Bayside Planning Panel

Item No	5.1
Application Type	Development Application
Application Number	DA-2017/353
Lodgement Date	15 May 2017
Property	47 Churchill Street, Bardwell Park
Owner	Mr P J Poulos and Ms V Patsos
Applicant	Michael Kitmiridis Architect
Proposal	Alterations and additions to existing dwelling comprised of ground and first floor addition, new front fence and vehicular footway crossing
No. of Submissions	Nil
Cost of Development	\$200,000
Report by	Michael Maloof, Senior Development Assessment Planner

Planning Assessment Report

Application Number:	DA-2017/353
Date of Receipt:	15 May 2017
Property:	47 Churchill Street, Bardwell Park NSW 2207
Owner:	Vicki Patsos and Peter John Poulos
Applicant:	Michael Kitmiridis Architect
Proposal:	Alterations and additions to an existing dwelling comprising of a ground and first floor addition, new front fence and vehicular footway crossing.
Recommendation:	Approval, subject to conditions
Submissions:	Nil
Author:	Creative Planning Solutions Pty Ltd: <ul style="list-style-type: none">– Prepared by: James Arnold, Senior Planner– Reviewed by: Ben Tesoriero, Director
Date of Report:	9 October 2017

Figure 2. West Elevation Streetscape
(Source: MKA, 2017)

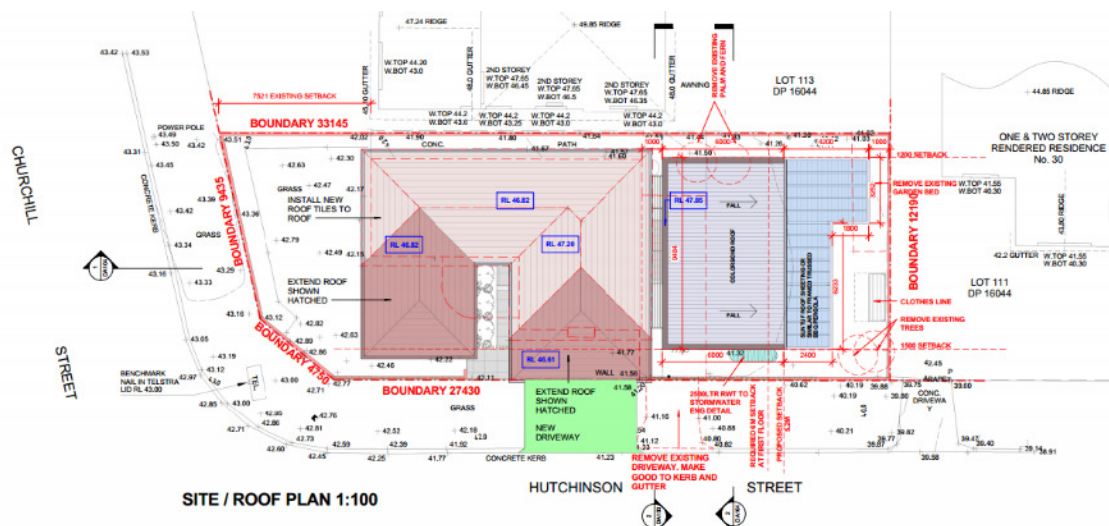
- **Streetscape** – The design of the proposed two-storey rear addition is considered to be incompatible with the streetscape which is inconsistent with a range of objectives and controls of the Rockdale Development Control Plan 2011 (RDCP2011). The streetscape is relatively consistent in architectural style and built form being predominately traditional red brick dwellings with pitched roofs, including the existing dwelling on the site. The design of the addition is considered to be overly rigid with a flat parapet roof and minimal fenestration or articulation to the street elevation. Given the prominence of the site on a corner and at the crest of a hill, this design is not supported. Conditions are recommended to resolve these design issues which will ensure the development will be more sympathetic to the character of the area.

Figure 20. 37 Benjamin Street, Bexley North – Example development provided by applicant to justify non-compliant streetscape presentation of proposal
(Source: MKA, 2017)

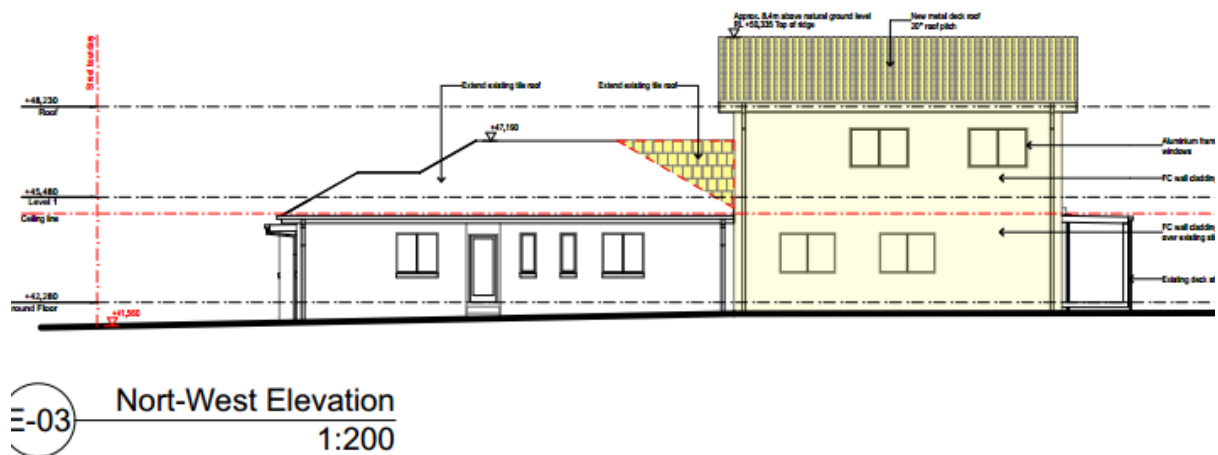
Comment: This development is a two storey rear addition located at the rear of the site. The addition has a pitched roof with gabled ends and windows across the elevations which is consistent with the original portion of the dwelling and the surrounding area.

Figure 21. 122 Croydon Road, Bexley – Comparison of proposal against the example development provided by applicant to justify non-compliant streetscape presentation of proposal (Source: MKA, 2017)

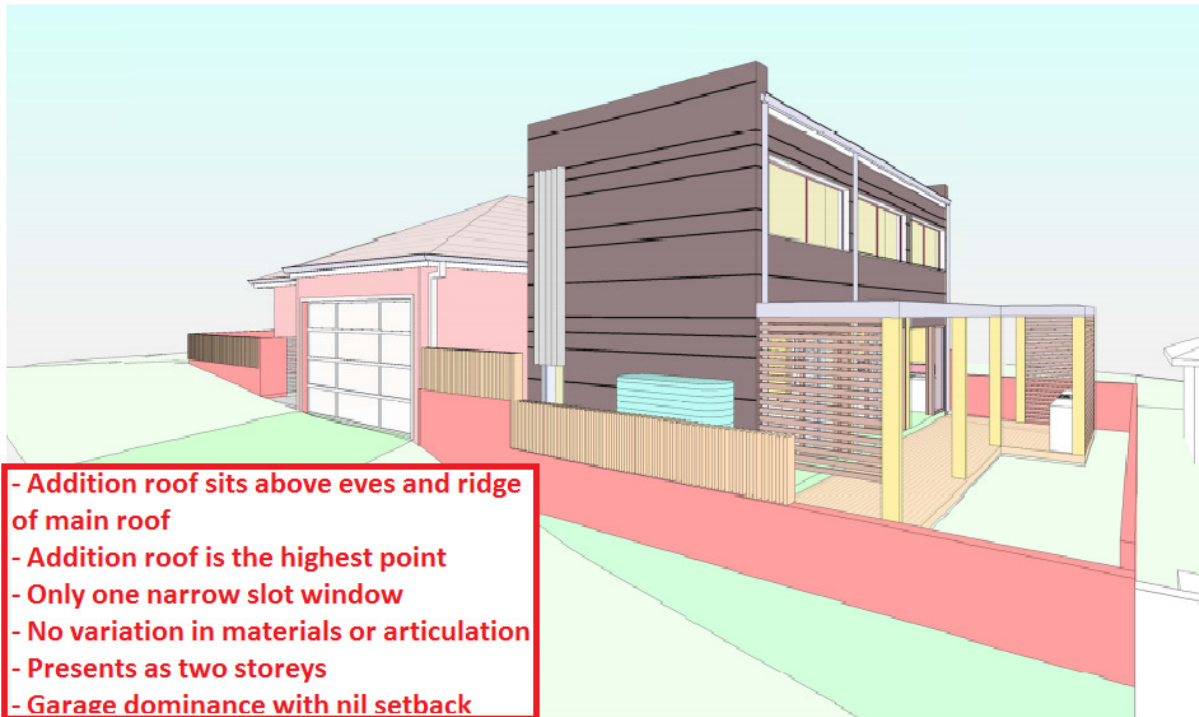
Comment: Of the examples provided by the applicant, this development is the only one which shares some similar characteristics and context to the proposal, being a contemporary rear addition to a traditional red brick dwelling located on a prominent corner site. Whilst there are these similarities, there are some important differences which make this development significantly more sympathetic to the streetscape.

As demonstrated in **Figure 21**, this development is less prominent than the proposal as the height only extends as high as the eaves of the original portion of the dwelling and presents largely as a single storey structure as the lower level sits well below the ground floor of the original and is screened by side fencing. The proposal has a flat roof which is higher than the ridge of the original dwelling and clearly presents as two storeys.

Figure 22. Marked Hutchinson Street Perspective indicating design improvements which were required to be made via the original recommended conditions.
(Source: MKA, 2017 marked by CPS, 2017)

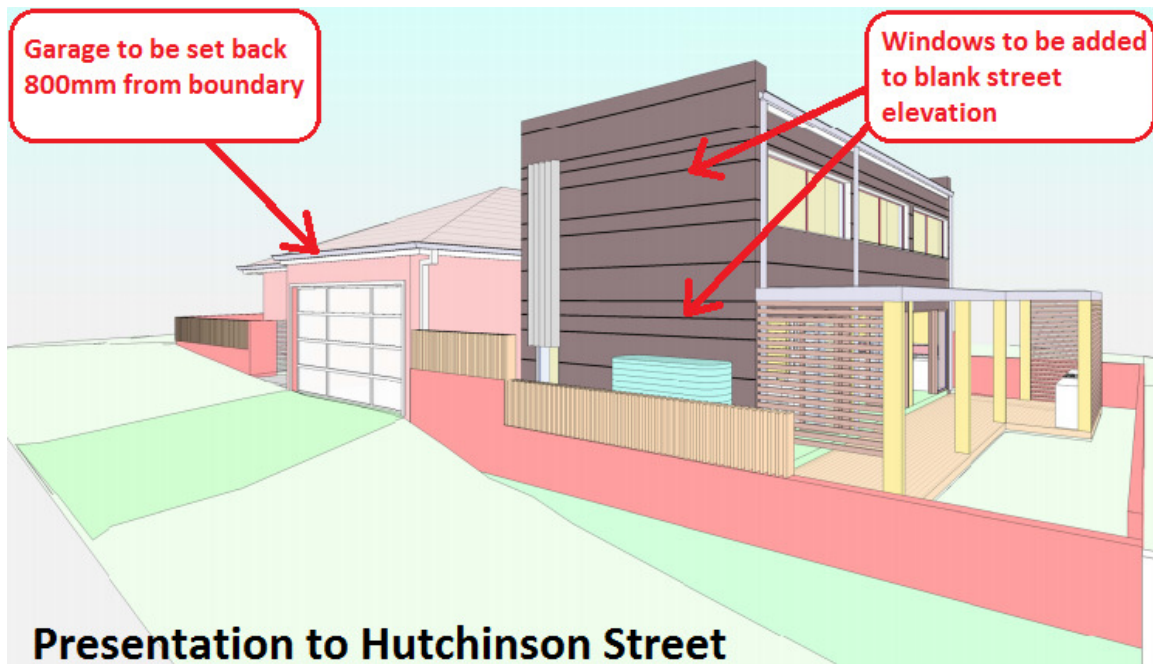
Given the above non-compliance in relation to streetscape presentation, conditions of consent are recommended to resolve the issues. It is recommended that the flat parapet roof be replaced with a skillion roof which will introduce a pitched roof and eaves. This is considered to be more sympathetic to the traditional pitched roofs in the area than the proposed flat parapet roof. Furthermore, it is recommended that the western street elevation be amended to include additional windows to the ground and first floor which will serve to soften and break up the uninterrupted mass of the wall.

In relation to the garage, a setback of 1.5m to Hutchinson Street is required under Part 5.1 of the RDCP 2011. The proposed double garage provides a nil setback to the street which is not acceptable as it will dominate the frontage and detract from the streetscape in this prominent location. As a result, a condition is recommended to set back the garage 800mm from the boundary. This will serve to better integrate the garage into the building and thereby reduce its dominance in the street. The plans have been reviewed, and an 800mm setback is achievable with only minimal internal changes required by relocating a small laundry and watercloset.

- *The flat parapet roof of the rear addition is to be replaced with a skillion roof with eaves, a minimum slope of 5 degrees, and is to slope down to the southern/rear of the site. The highest point of the roof must be no higher than RL 50.05 to remain under the 8.5m height limit applicable for the site; and,*
- *A window to the western street elevation of the rear addition is to be added to both the ground floor living area and the first-floor study room to soften the western elevation.*

- A window to the western street elevation of the rear addition is to be added to both the ground floor living area and the first-floor study room to soften the western elevation; and
- The front setback of the proposed garage from the Hutchinson Street boundary is to be increased to a minimum of 800mm.

Figure 23. Marked East Perspective demonstrating that there will be no privacy issue from the rear deck.
(Source: MKA, 2017 marked by CPS, 2017)

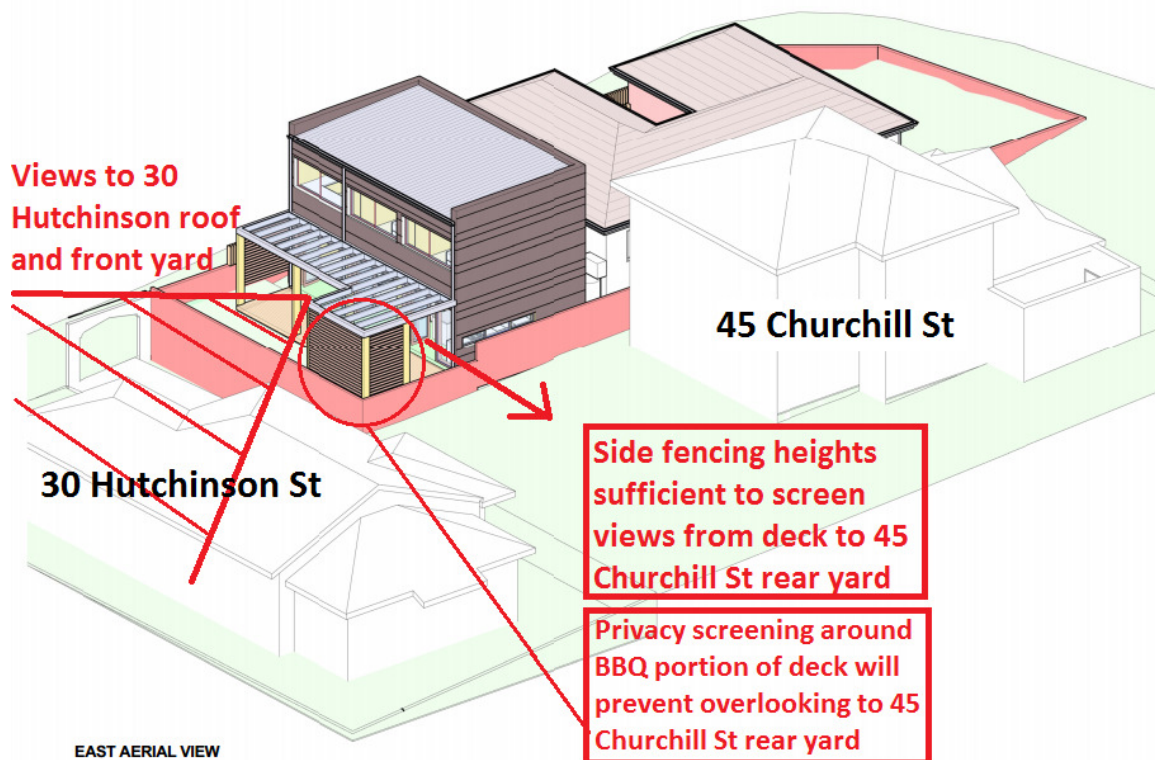
As demonstrated in **Figure 23** and **Figure 24** views from the proposed rear deck, which will be raised up to 300mm above the existing ground level, will not impact the privacy of neighbours. The views will primarily be oriented to the front yards of the dwellings to the south fronting Hutchinson Street, and given slope of the street will only overlook the rooftops of these dwellings. The highest raised portion of the deck being the BBQ area includes privacy screens to the south and west which will prevent views to rear yard of 45 Churchill Street.

Figure 25. Marked First Floor Plan demonstrating that there will be no privacy issue from the first floor.
(Source: MKA, 2017 marked by CPS, 2017)

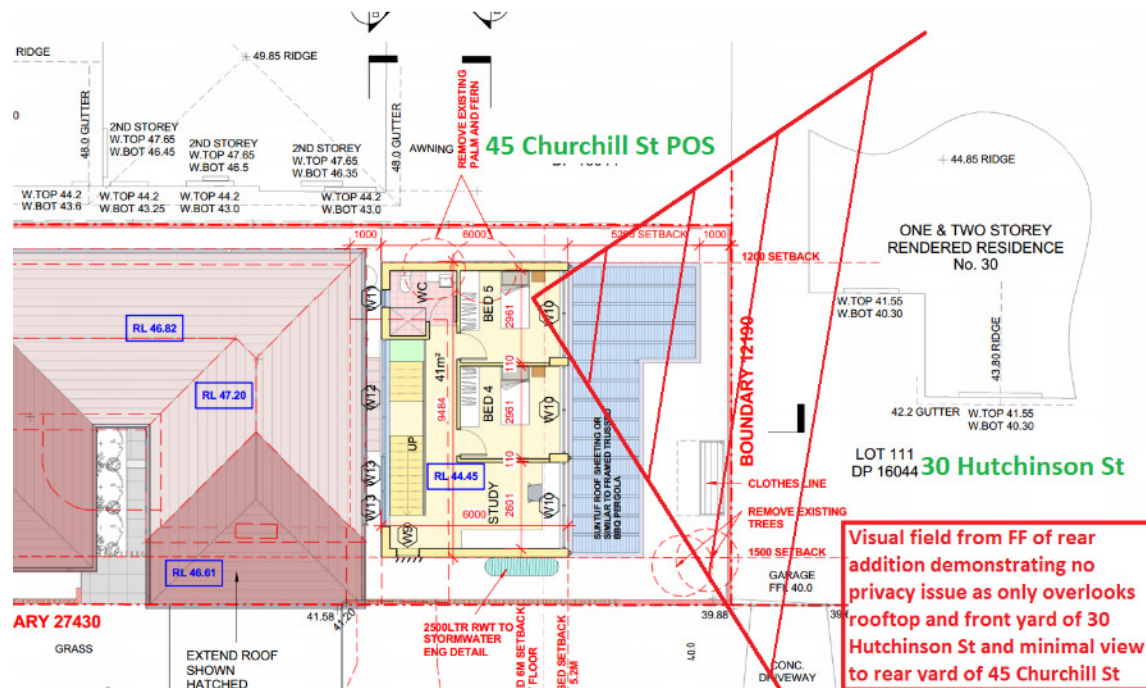
In relation to the first floor of the rear addition, this only includes bedrooms and no side facing windows. The views from the bedrooms will only overlook the front yards and rooftops of the dwellings to the south fronting Hutchinson Street. This visual field is illustrated in **Figure 25**.

- In terms of privacy implications, the first floor only contains bedrooms which will not facilitate any close or direct views to neighbouring habitable windows or private open space as demonstrated in **Figure 25** above; and,
